HTGR-SC/C PROGRAM BASELINE REVIEW MEETING

SESSION IIC

CIRCULATORS, C&I, & HELIUM SERVICE

DECEMBER 9-11, 1981

FIG. 1 - MAIN CIRCULATOR SERVICE CONNECTIONS

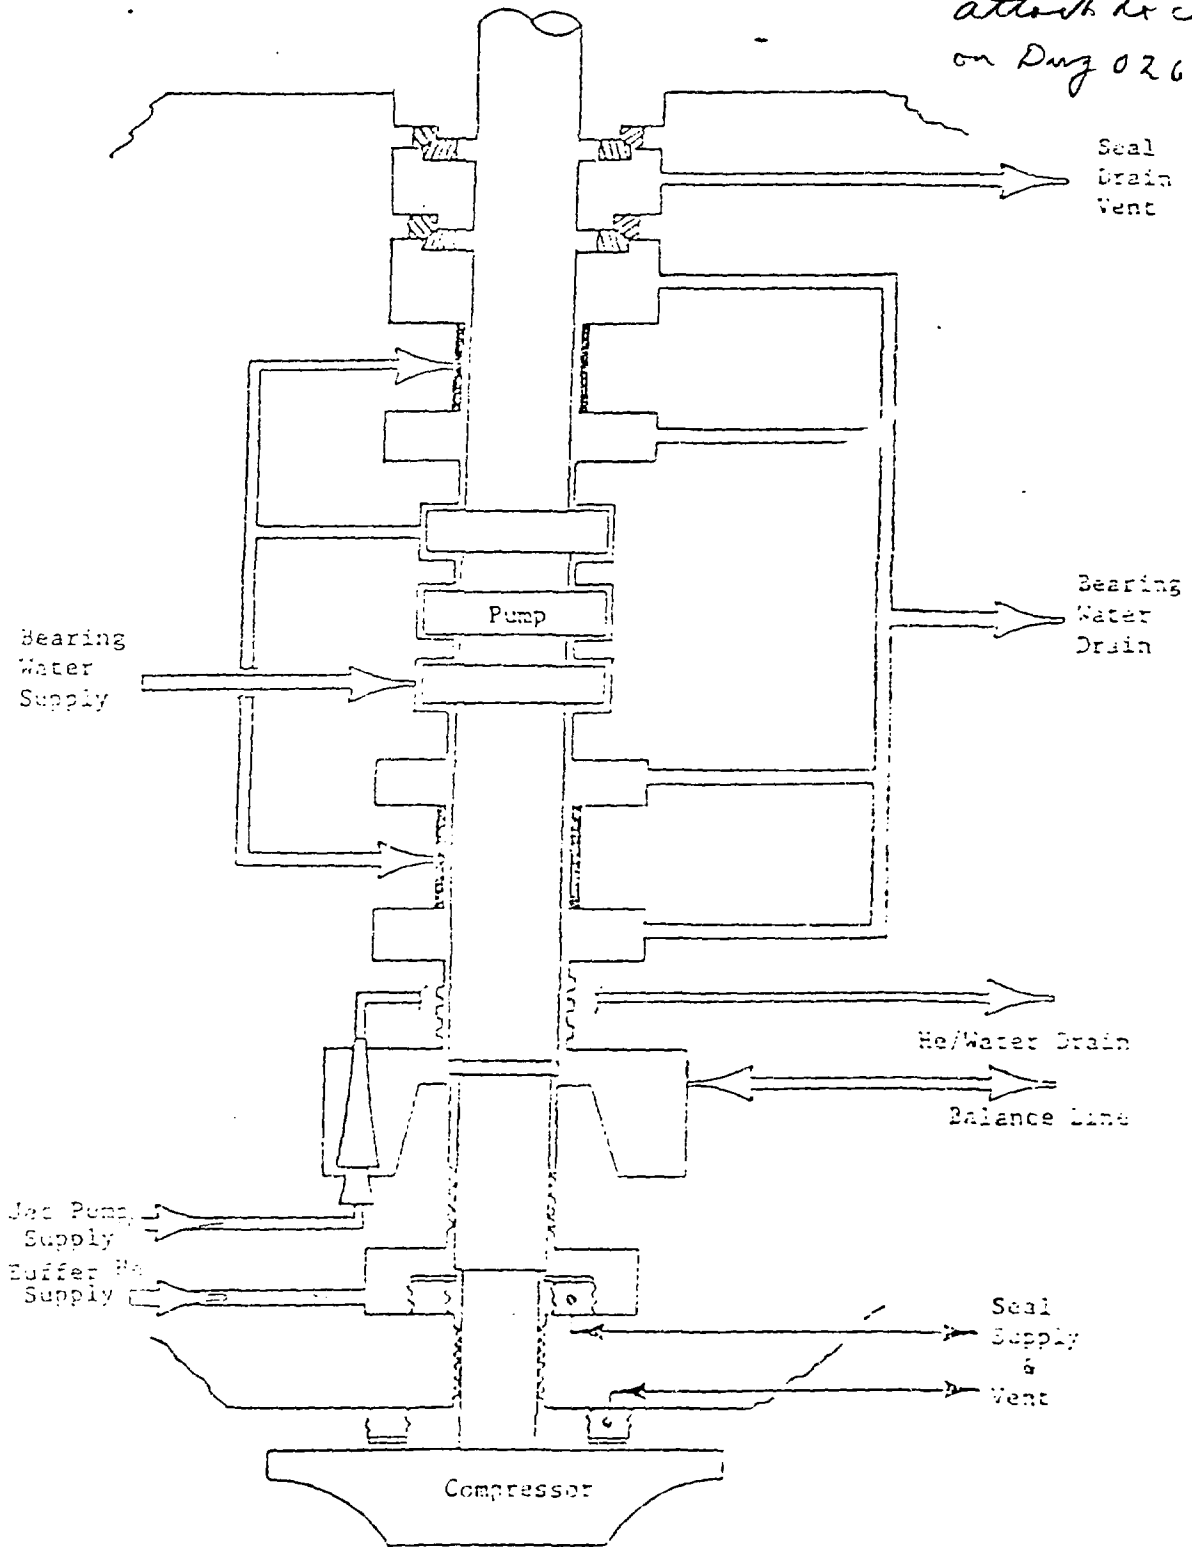
I am not able to tie the return and supply lines on Drawing 026950 with the sketch of the main helium circulator service connections. It would clarify the operation of the system if the attached figure were phantomd in the drawing to show the complete system.

The viewgraph of this system used in GA's formal presentation provided the suggested information with great clarity. GA agreed as an action item to add the requested information or to substitute the viewgraph drawing.
